SUNDRY NOTICES AND REPORTS ON WELLS
Do not use this form for proposals to drill or to re-enter an abandoned well. Use form 3160-3 (APD) for such proposals.

8. Well Name and No.
WD MCINTYRE E 7

9. API Well No.
30-015-31786

**WD McIntyre E 7
30-015-31786
COG Operating LLC
April 17, 2018
Conditions of Approval**

McIntyre WD E #7 Wellbore diagram updated

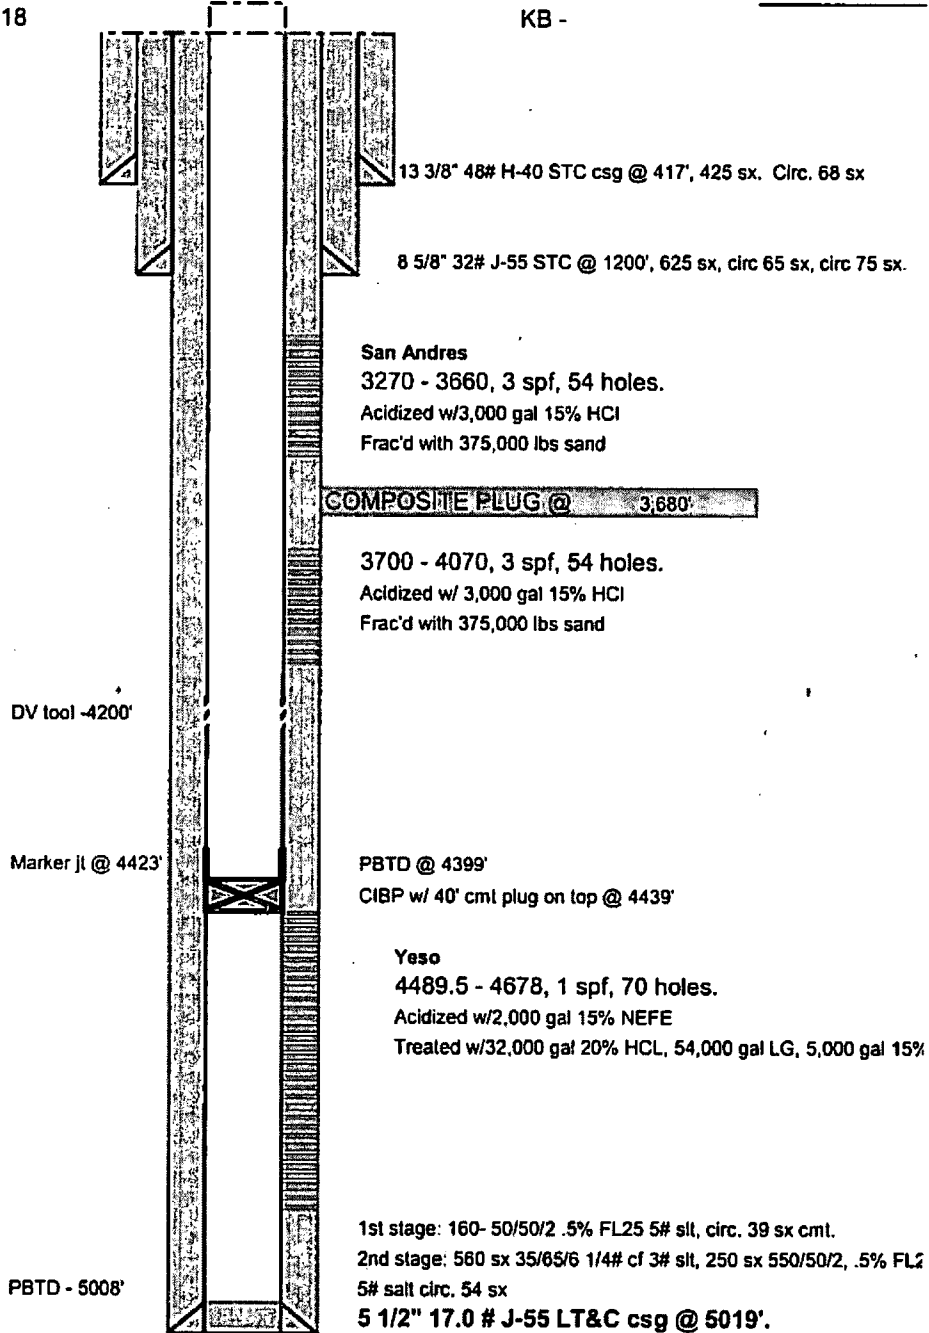
- 1. Operator shall place a CIBP at 4,439' and place 40' Class C Cement on top of the CIBP. WOC and TAG.**

Note: At a later date, operator will need to add 110' of cement to the CIBP to properly seal the Glorietta Formation.

- 2. Must conduct a casing integrity test before perforating and fracturing. Submit results to BLM. The CIT is to be performed on the production casing to max treating pressure. Notify BLM if test fails.**
